RE: Landfill Gas Monitoring Plan
White Oak Municipal Solid Waste Landfill
Permit # 44-07
Haywood County, North Carolina

APPENDIX 3
EXPLOSIVE GAS CONTROL PLAN

FIGURE 1

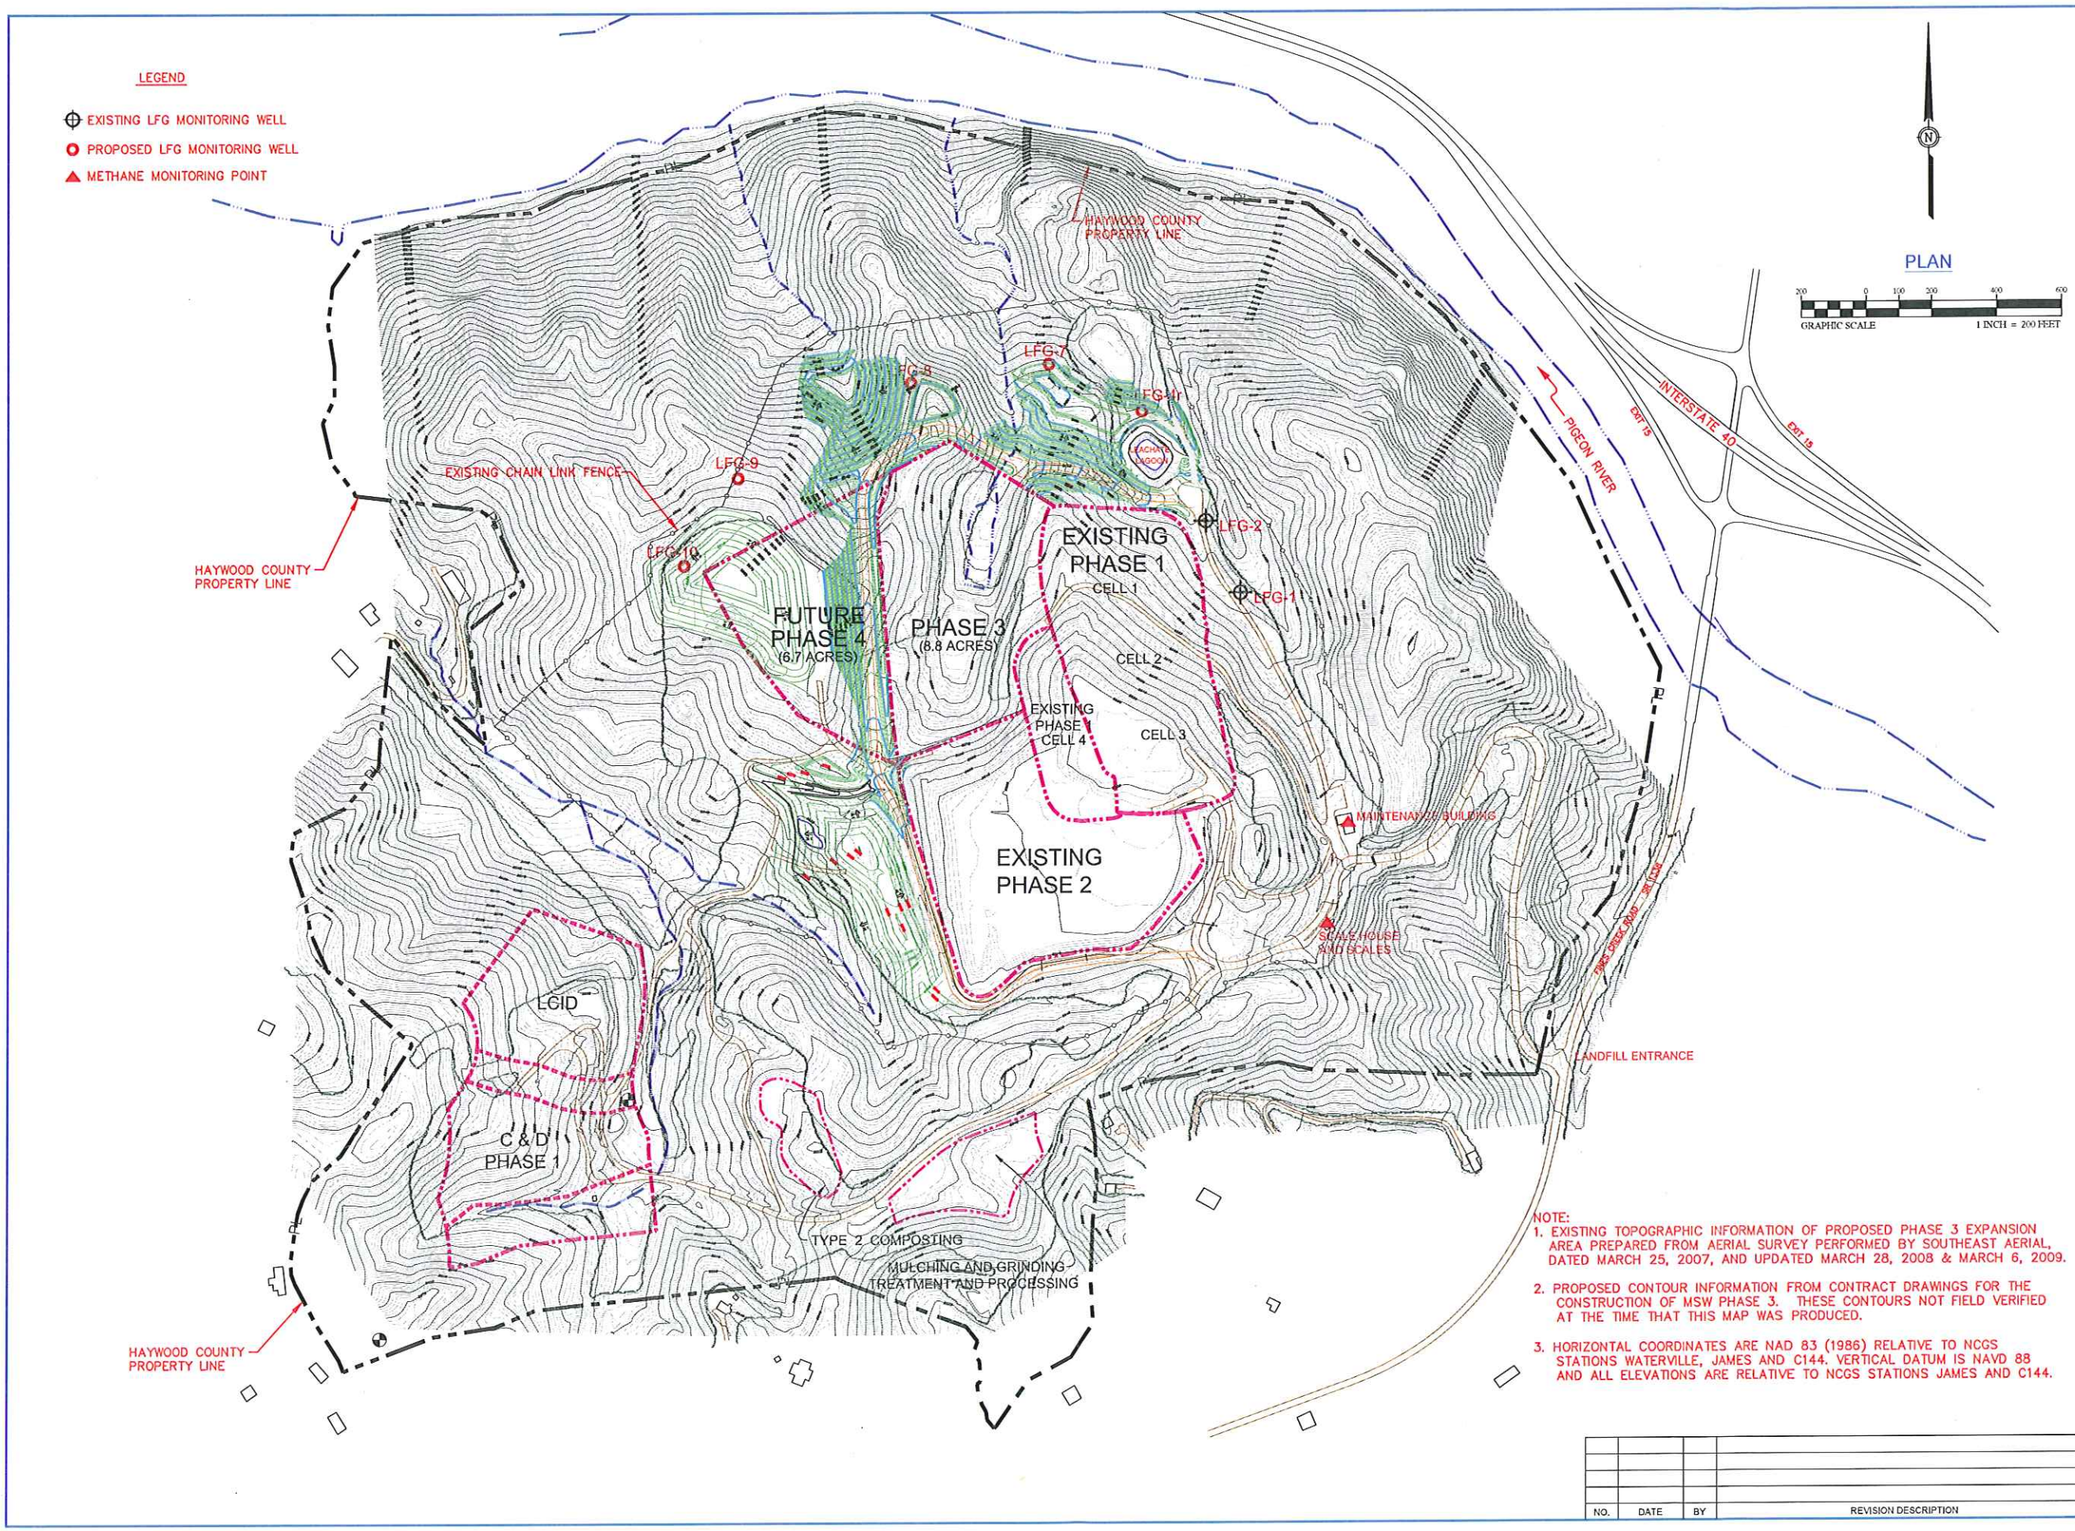
The spacing and number of the existing and proposed landfill gas monitoring wells, approved as a part of the afore referenced Permit To Operate and Permit To Construct are generally within a lateral spacing of no more than five hundred feet (500') and no further than two hundred fifty feet (250') from the waste boundary. Exceptions to the location criteria are due solely to the topography of the surrounding terrain and the need to provide access to the wells in order to facilitate installation and conduct monitoring activities.

FIGURE 2

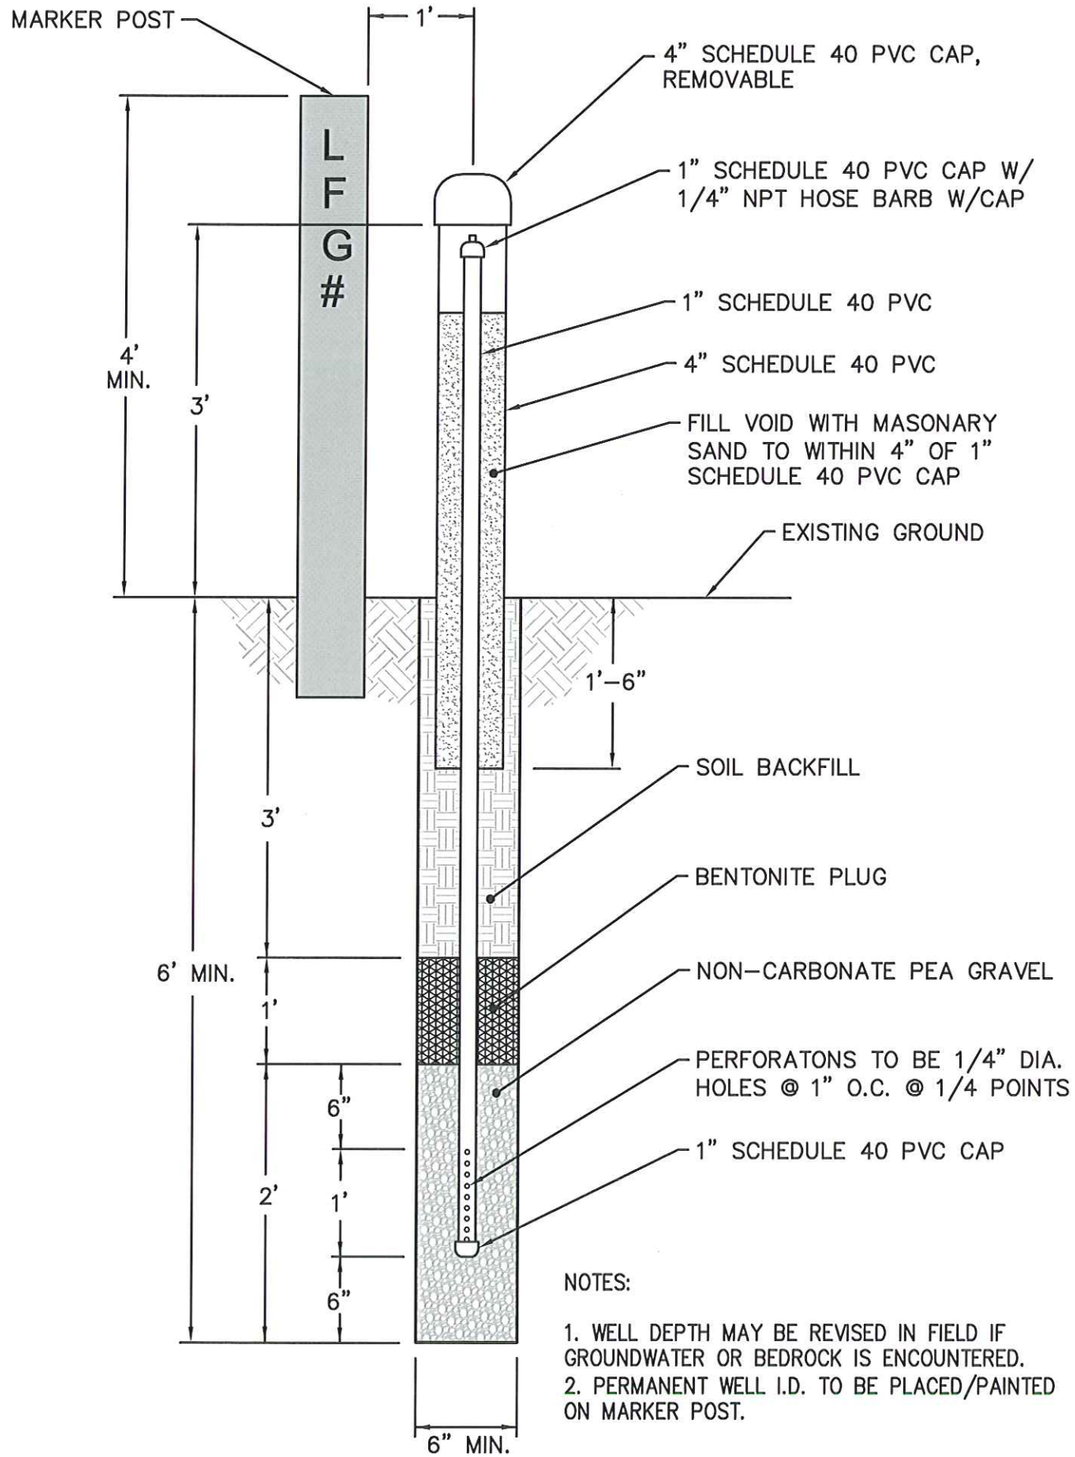
In response to Mr. Barbee's specific comment that "well depths will extend to the seasonal high groundwater elevation and the entire vadose zone, including bedrock above the water table will be screened", the County's opinion is as follows. The County's landfill is designed with a synthetic membrane base liner underlain with applicable thicknesses of compacted low permeability soil to prevent contaminants from leaking through and impacting the groundwater. This same synthetic membrane base liner will prevent the migration of landfill gas through and into the adjacent subsurface soils. The primary explosive component of landfill gas is methane which is lighter than air. Methane does not generally migrate downward but will attempt to escape vertically upward or may travel horizontally through any pathway or permeable *in situ* soil. It is also known that landfill gases move from areas of high pressure to areas of lower pressure through the path of least resistance. Within the landfill's waste mass the gas may migrate laterally; however, at some point the gases must migrate vertically in order to exit the lined landfill area. Since the synthetic membrane is anchored at or near the surrounding surface of the existing terrain, the landfill gas that does not exit the landfill through the cap system may follow the membrane liner upwards and generally vent to the environment at or near the edge of the anchor trench. Given that any landfill gas that may migrate beyond the perimeter anchor trench of the lined cells would only be a couple of feet below the surrounding surface at the initial point of migration, it is highly unlikely that it would travel far before venting to the atmosphere. In addition, the topography surrounding the disposal areas acts as a natural barrier minimizing the possibility of landfill gas migrating much beyond the edge of the anchor trench. The landfill cells are generally bounded by drainage channels, downward sloping terrain or valleys that are equal to or lower in elevation than the adjacent top of the synthetic membrane anchor trench. In addition, the ground elevation at the majority of the landfill gas monitoring wells is generally well below the elevation of the anchor trenches. This has the same effect as placing a much deeper monitoring well immediately adjacent to a cell's anchor trench. However, should the landfill gas, under the most extreme circumstances, migrate away from the edge of the anchor trench, it will generally be a very shallow migration and will be detected in the six-foot (6') deep landfill gas monitoring wells. The County is therefore of the opinion that the site conditions at the Haywood County MSW Landfill do not warrant the drilling of methane monitoring wells to the depth equivalent to the seasonal high groundwater elevation. The landfill gas monitoring wells installed at a depth of approximately six-feet (6') below the surface should provide more than adequate detection of migrating landfill gas should that occur.

The detail of the landfill gas monitoring well will be modified to change the title from "Landfill Gas Monitoring Probe" to "Landfill Gas Monitoring Well" to comply with the general change in wording requests as noted in Mr. Barbee's afore referenced comment letter. However, for the reasons stated above, the County is of the opinion that the monitoring well, as shown on the detail, is more than adequate to meet the landfill gas monitoring requirements for the White Oak MSW Landfill site.
